CONSTRUCTION CHANGE ORDER NO. 1

Project: Welcome Center Trail Reconstruction
 AEI Project #: 2022-357
 Owner: City of Deadwood
 Engineer: Albertson Engineering Inc.
 Contract Date: June 3, 2024
 Date of Issuance: 9/05/2024
 Issued to: Rogers Construction Inc., 722 14th Street, Sturgis, SD 57785
 Distribution to: Owner Engineer Contractor

REQUEST FOR PROPOSAL

Welcome Center Trail Reconstruction

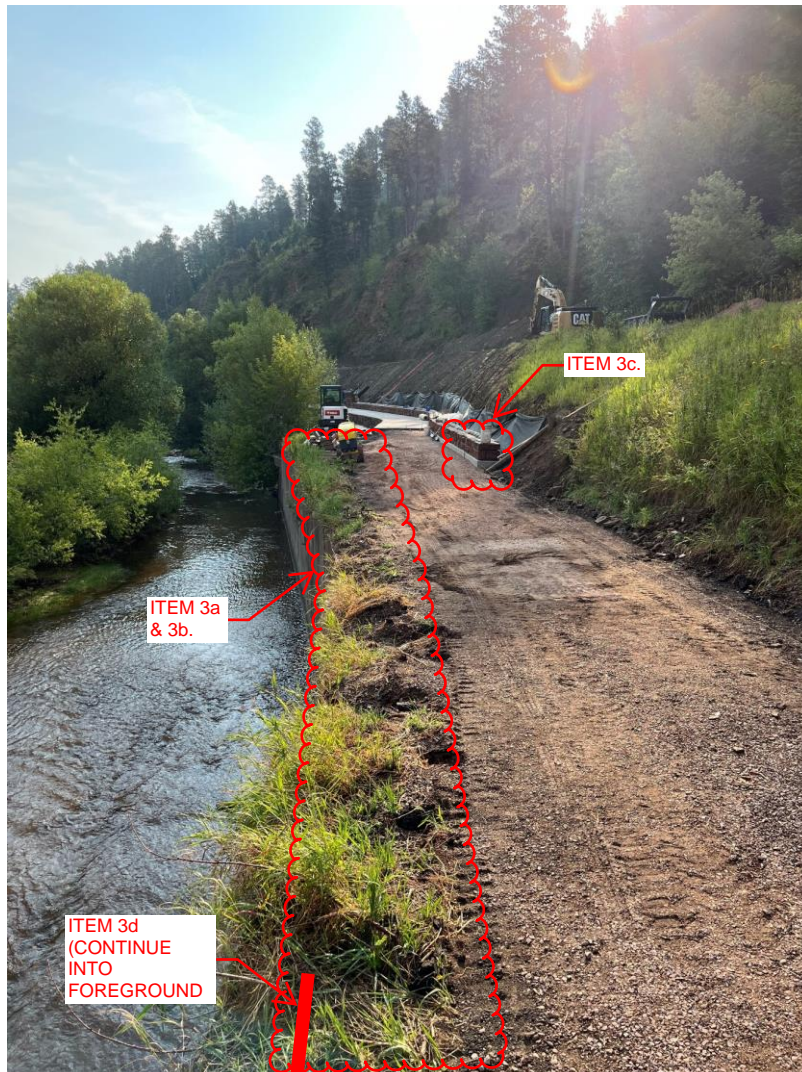
1. Provide (1) Redi-Rock precast blocks set atop upper retaining wall for all light posts except for westernmost light pole. At westernmost light, use (2) precast blocks set on grade.
2. Add approximately 114 square feet of sidewalk concrete paving at the easternmost tie-in area of the project. This is the area recently damaged by a falling boulder unrelated to this project.
3. As discussed on-site on August 8, 2024:
 - a. Align remaining portion of west end of trail sidewalk more uphill to gain 12” to 24” more inches between new sidewalk and existing culvert retaining wall.
 - b. For the landscaping area between the edge of sidewalk and existing culvert retaining wall, place weed barrier fabric and gravel to match the gravel along the sidewalk at the Sherman Street Parking lot.

- c. Saw-cut very end (approx. 5 feet of length) of exposed footing in order to realign that end of the wall more uphill. Also realign those end blocks more uphill.
- d. At very western end of existing culvert retaining wall, anchor treated timber atop wall to gain up to 12” of height. This will allow for less steep rock landscape area. City shall supply the wood and Contractor shall install.
